THE VILLAGES AT STERLING RANCH PUD DEVELOPMENT PLAN / PRELIMINARY PLAN

LETTER OF INTENT

JUNE 2022 | REVISED JUNE 2024

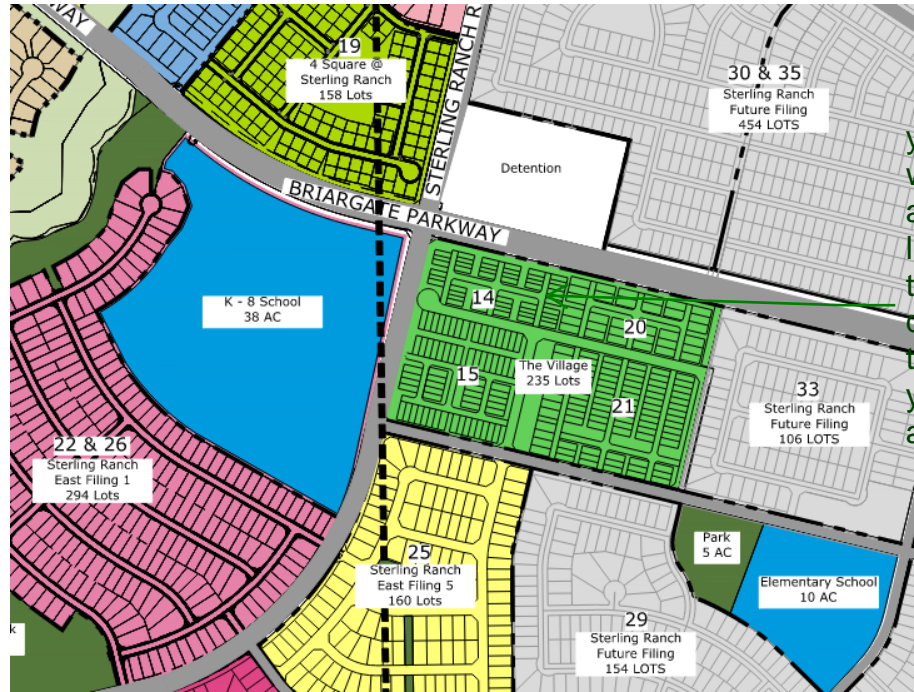
name the intersection: there are multiple depicted

you may want to use a leader/label to depict density transitions your writing about.
